Sub-Regional RTEP Committee PJM South

SRRTEP - South
July 26, 2016

Dominion Transmission Area

S0921 Cost Increase

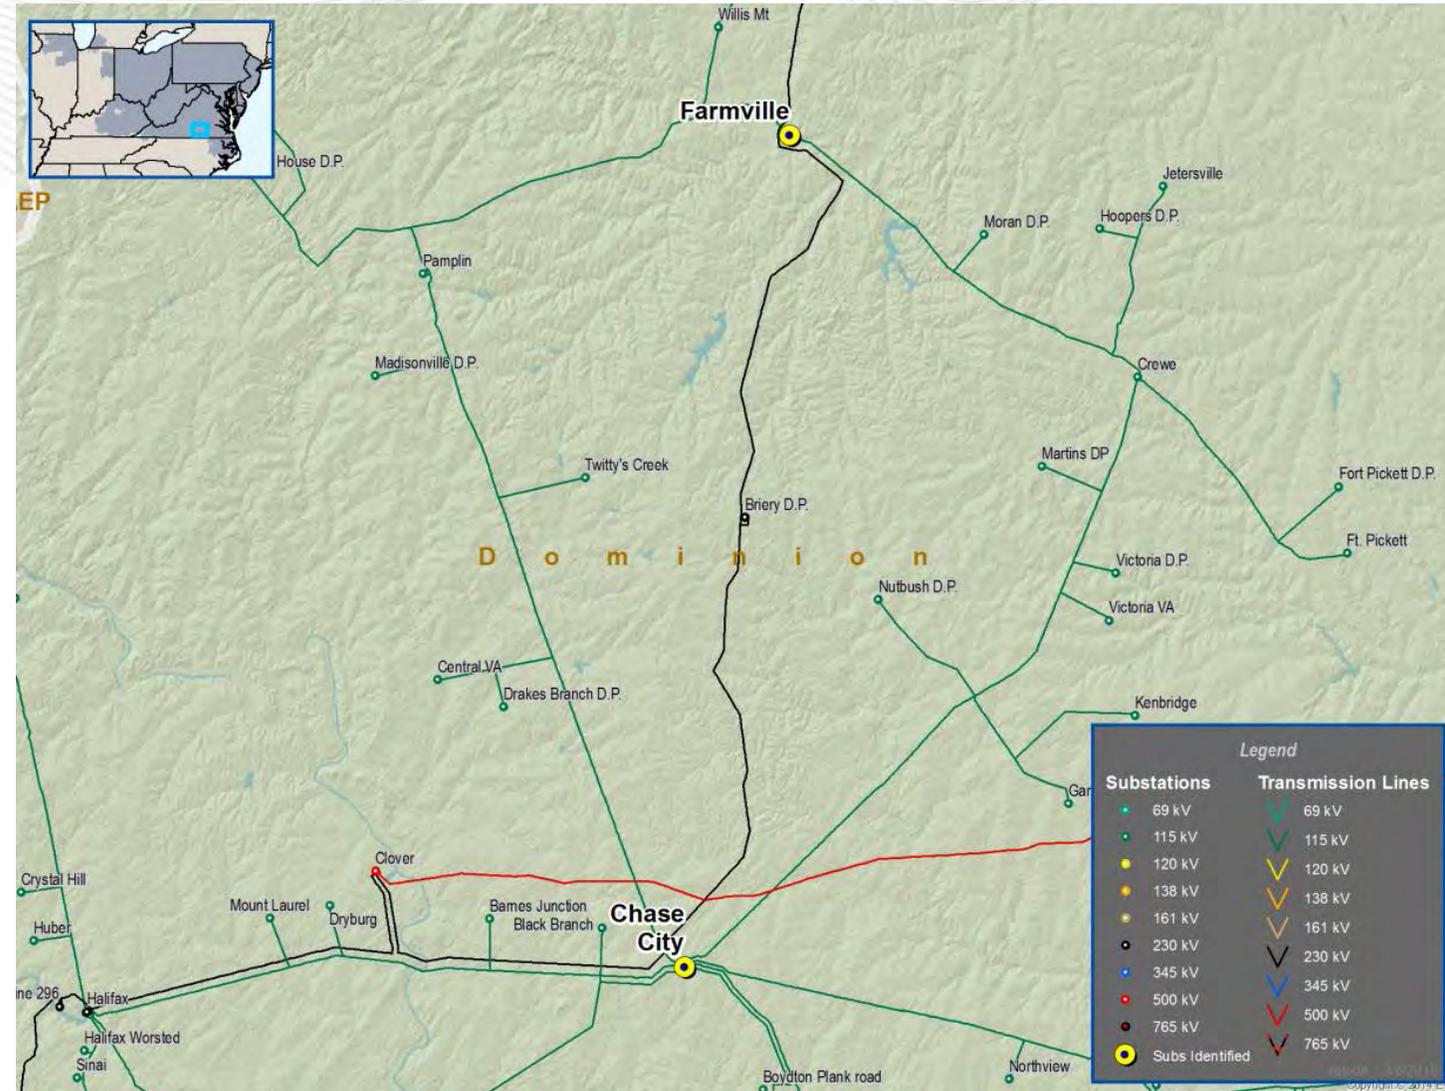
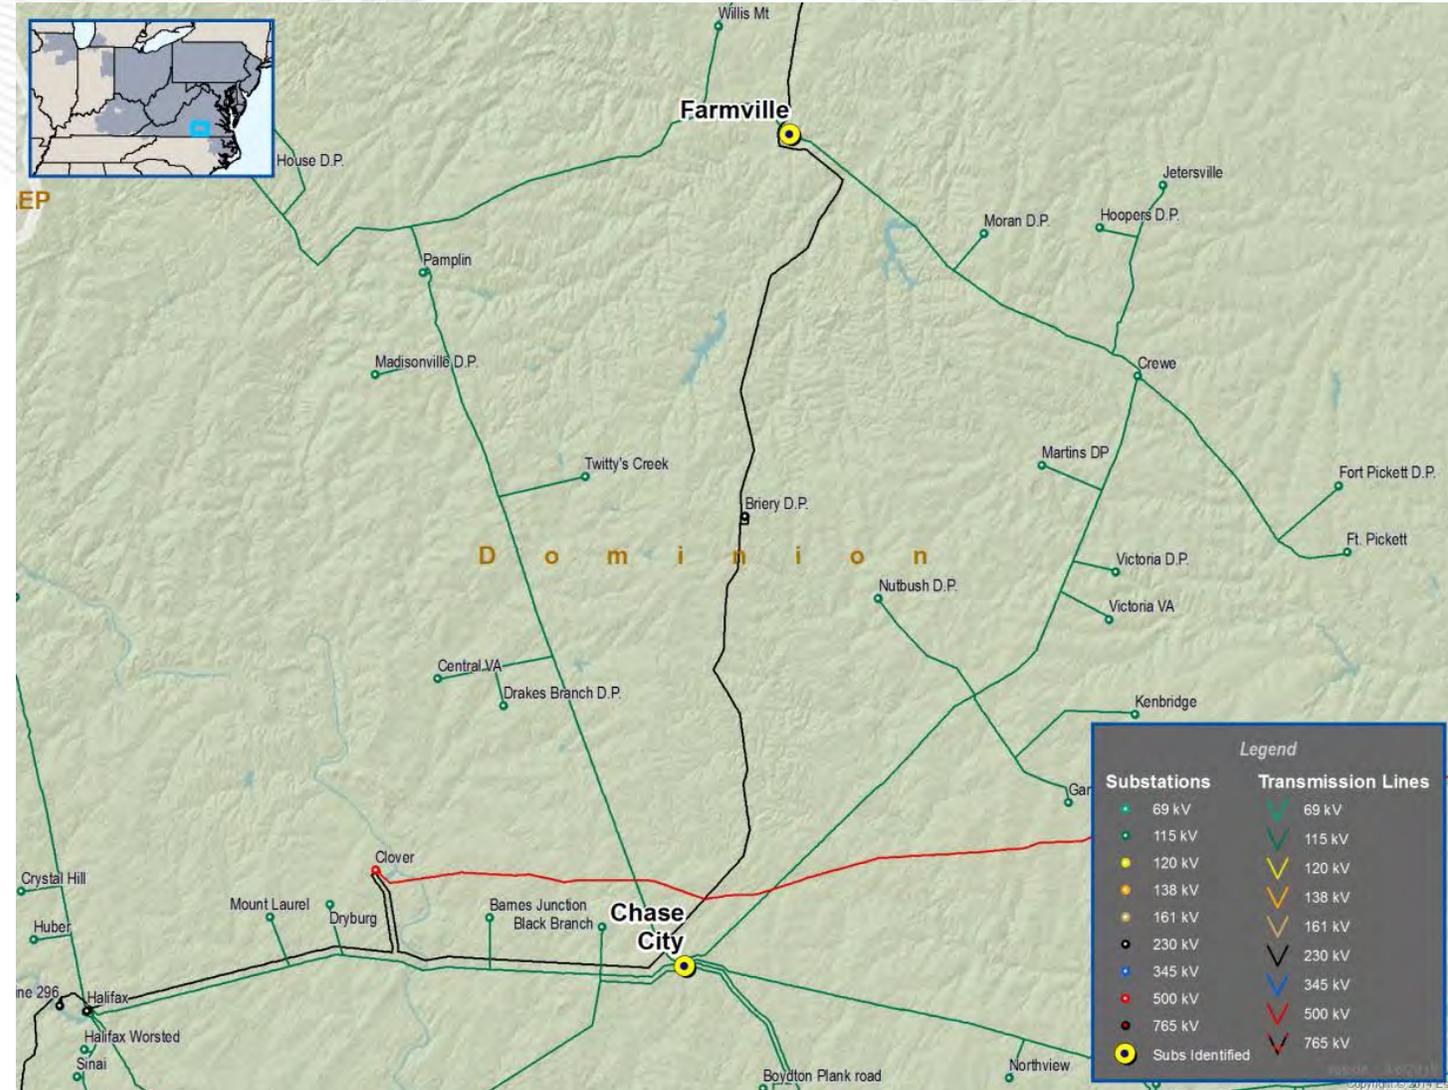
S0921 Cost Increase Reasons for Cost Increase

- Due to overruns in projects over the last 18 months, rates have increased to reflect the latest costs.
- The project affects 11 different sites including Lone Pine, Pamplin, Lunenburg, Twittys Creek, Farmville, Willis Mount, Victoria, Chase City, Crewe, Jetersville, and Fort Pickett. The work required at these substation is estimated at \$24.4M.
- Considerable transmission line re-work is required at Lone Pine, Lunenburg and Pamplin which is estimated at \$9.4M.
